<b>AMENDMENT OF SOLICITATION / MODIFICATION OF CONTRACT</b>			1. CONTRACT ID CODE	PAGE 1 OF PAGES 2
2. AMENDMENT/MODIFICATION NO. A00003	3. EFFECTIVE DATE 10/24/95	4. REQUISITION/ PURCHASE REQ. NO.		5. PROJECT NO. (If applicable) CIN-07
6. ISSUED BY U. S. Army Engineer District, New Orleans Corps of Engineers P.O. Box 60267 New Orleans, LA 70160-0267		7. ADMINISTERED BY (If other than Item 6)		
8. NAME AND ADDRESS OF CONTRACTOR (No., street, county, State and ZIP Code)  B & K Construction 1905 Highway 59 Mandeville, LA 70448			(X)	9A. AMENDMENT OF SOLICITATION NO.
				9B. DATED (See Item 11)
			X	10A. MODIFICATION OF CONTRACT/ ORDER NO. DACW29-94-C-0079
CODE OGTN3	FACILITY CODE			10B. DATED (See Item 13) 07/11/94

The following change is made to the above numbered contract for Lake Pontchartrain, LA & Vicinity, HLP, London Avenue Outfall Canal, Parallel Protection, Mirabeau Avenue to Leon C. Simon Boulevard Floodwall, Orleans Parish, LA, to revise the alignment of the floodwall from WB/L Station 70+47 to WB/L Station 84+54.77 and WB/L Station 85+90 to WB/L Station 99+83.67 to a position 4 feet to the flood side of the original alignment as requested by a Contractor Value Engineerin

## VE CP

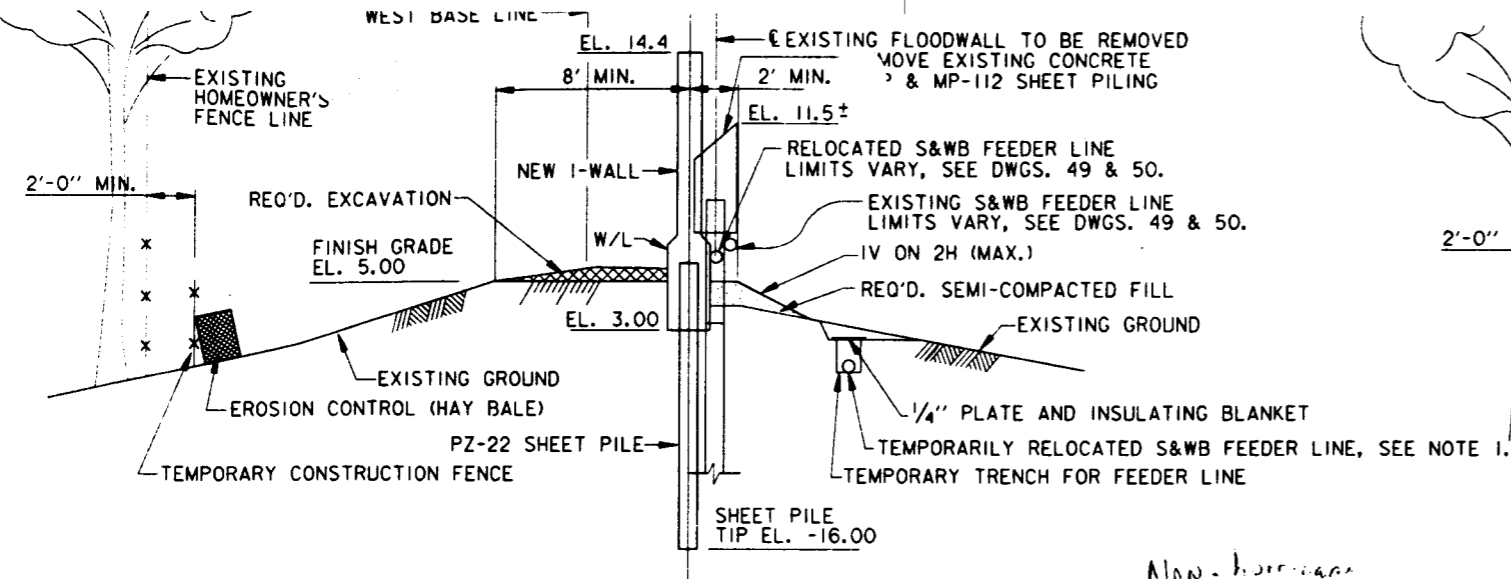
1. CUT CAP off Sheet pile by  
Cutting Sheetpile @ elevation 6.75
2. Sheetpile & concrete cap is hauled away  
to PMC where the concrete is removed from the  
metal.
3. Pull Sheets as originally planned on cut-off  
6" below final grade

### Original contract.

- 1.) cut off cap by cutting sheetpile below the cap.
- 2.) Haul off concrete cap & sheetpile embedded
- 3.) pull sheets as required.

Plan I-Wall

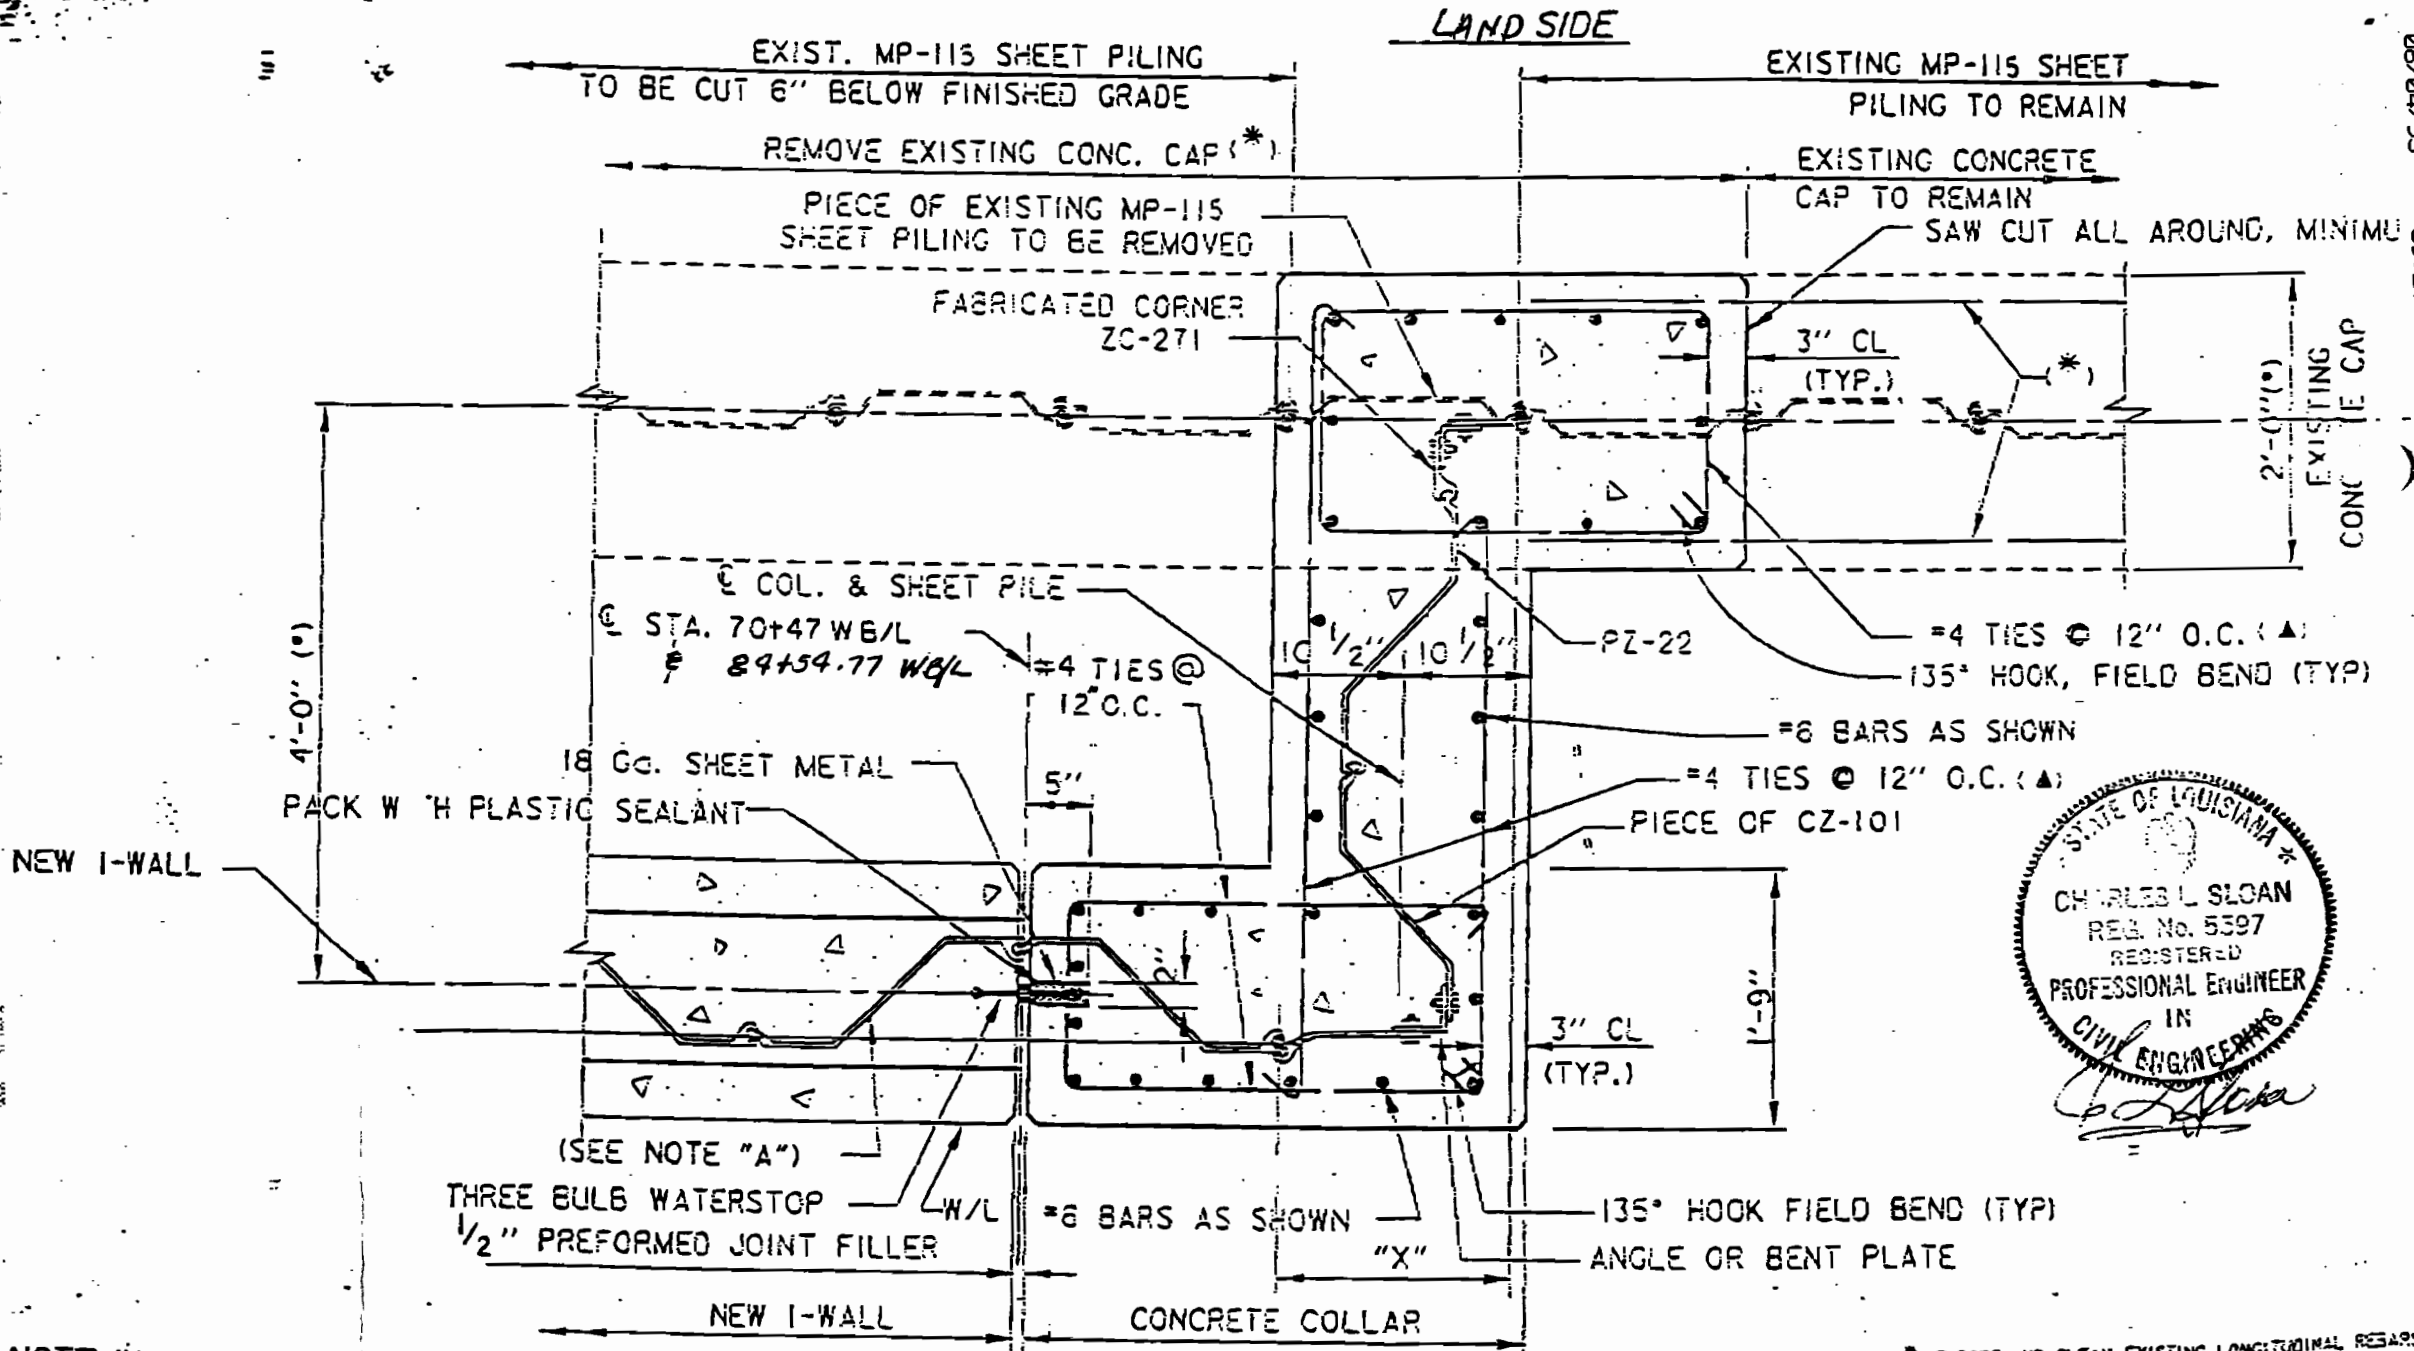
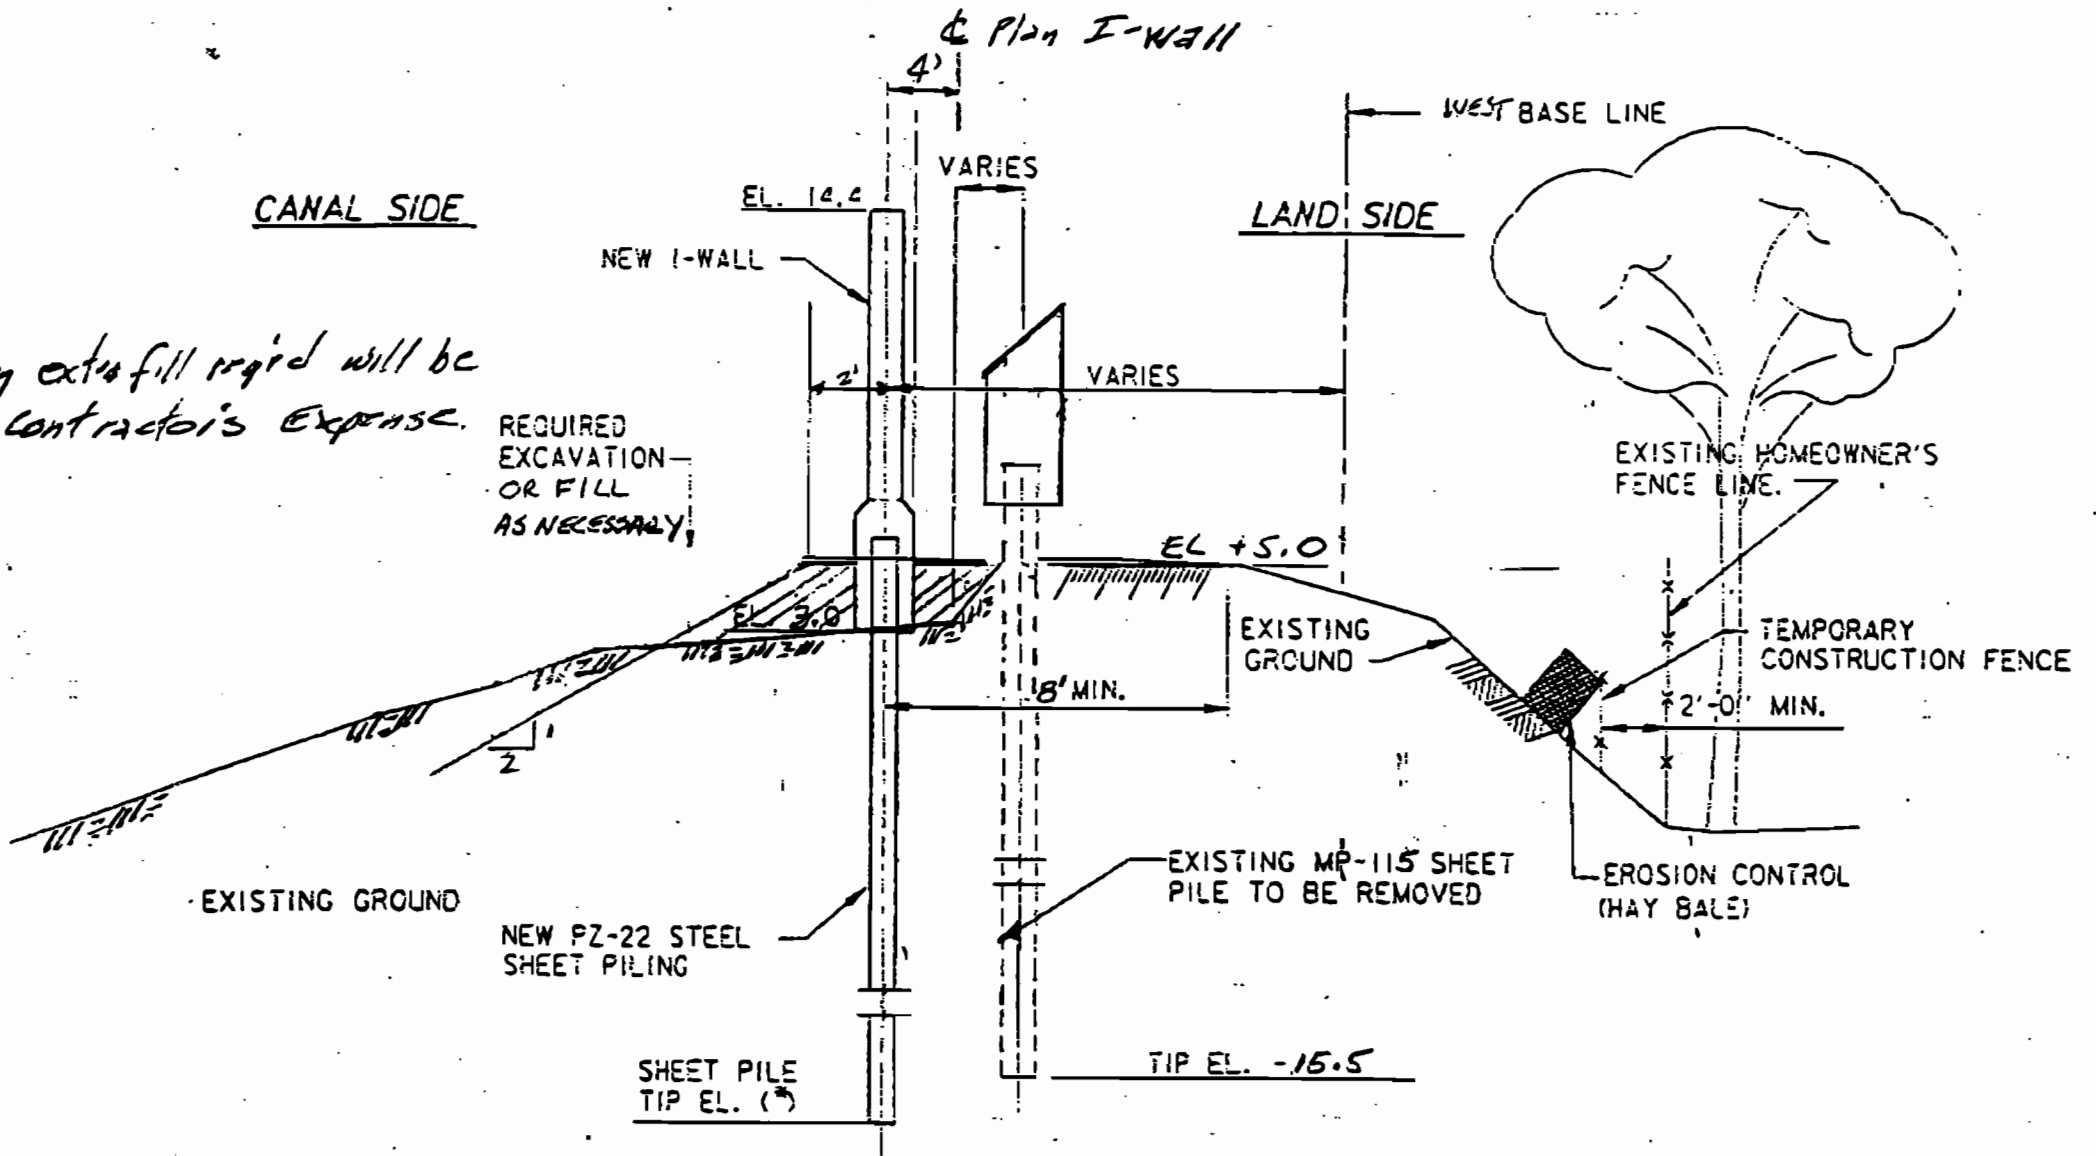
**NOTE "A":**

COLLAR TO INCLUDE AT LEAST ONE CZ 101 SO THAT WHEN COLLAR IS REMOVED FOR FUTURE I-WALL THERE IS A SHEET PILE TO INTERLOCK FUTURE SHEET PILING TO EXISTING SHEET PILING.

- (\*) EXPOSE AND CLEAN EXISTING LONGITUDINAL REBARS AND EXTEND THESE REBARS 1'-8" INTO THE NEW CONCRETE COLLAR.
- (A) ALL TIES ARE TO BE FIELD TIES.
- (B) #6 L-BARS TO LAP #6 BARS AS SHOWN IN PLAN AT EL. 5.00

NOTE: Any extra fill required will be at contractor's expense.

1. The contractor's proposal for changing the wall alignment between Sta. 85+90 and Sta. 99+83.67 WB/L is technically acceptable.
2. Request you take the necessary actions for completion of modification. Furnish a copy of the finalized modification to the Value Engineering Officer.
3. POC is Robert Guillot at ext 2938.
